**Date: 26 July 2021**

**To:** Auckland Transport

**Re:** Broadway / Teed Street Signalised Crossing Review

Figure 2. Broadway/Remuera Road signal phase diagram

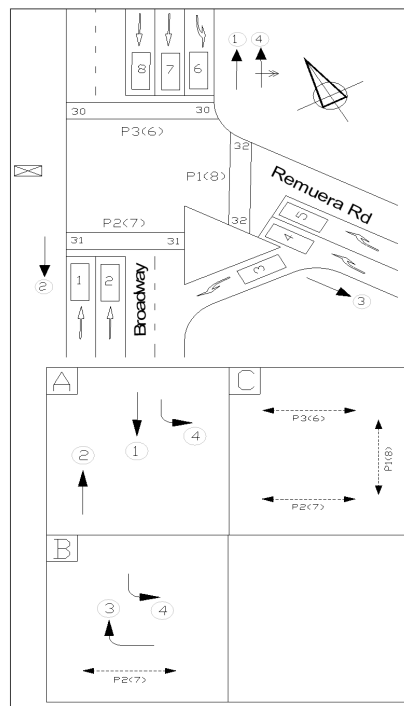
Option 2 resulted in an increase in the total travel time of around 24 vehicle-hours (12 seconds / vehicle). This is as a result of the increased inter-green time between phases A and C and then B and A which is required due to the increased distance vehicles need to travel to clear the intersection.

Figure 3: Option 1 during pedestrian phase (5:00pm)

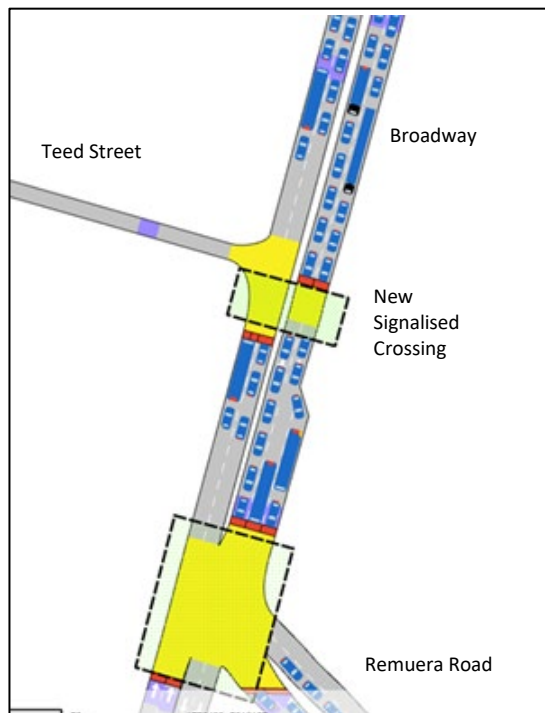
Analysis of the model showed the pedestrian crossing operating well for Option 1. Vehicles would be held between the new signalised crossing and the Broadway/Remuera Road intersection on the pedestrian crossing phase (phase C) which is illustrated in figure 3 below.

It is considered that Option 1 consisting of a new signalised mid-block crossing is the preferred option as it provides a high level of pedestrian amenity, increases pedestrian safety and minimises impact on the operation of the surrounding network.

Figure 4: Option 2 during pedestrian phase (5:00pm)

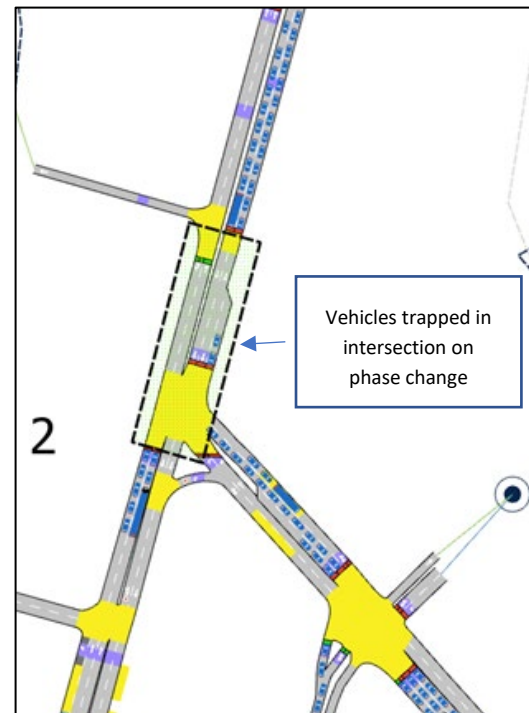
The model of Option 2 showed vehicles being regularly 'trapped' in the intersection area resulting from queuing back from the Remuera Road/Nuffield Street intersection which can be seen in figure 4 below. Drivers will be unable to determine if they can clear the intersection due to the lack of visibility of queues between Broadway (north) and Remuera Road.
